Subject: **VERTICAL LINE**

Model: **HDM-2830**

Serial No: **2,100,036 AND HIGHER**

Figure 1

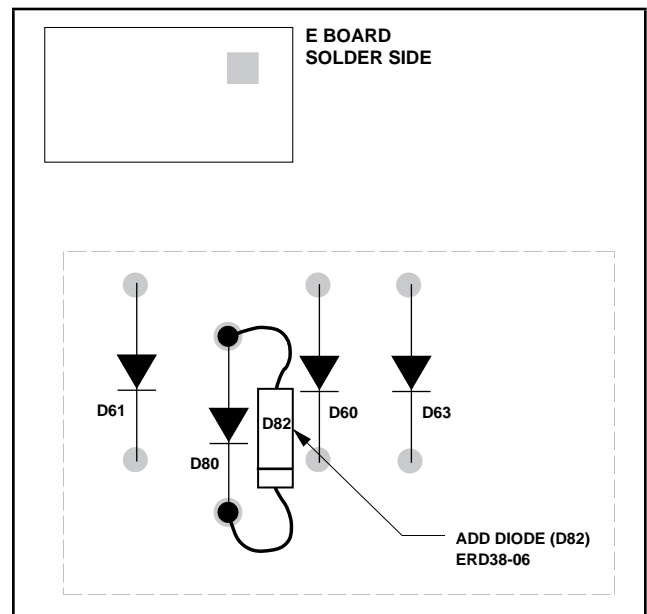
A brighter vertical line may sometimes appear near center of the display image. To correct this, modify the E board by soldering a ERD38-06 diode in parallel to D80 as shown in Figure 1. Ensure that the cathode of the new diode is at least 2mm away from D63, and affix the diode to the board with RTV.
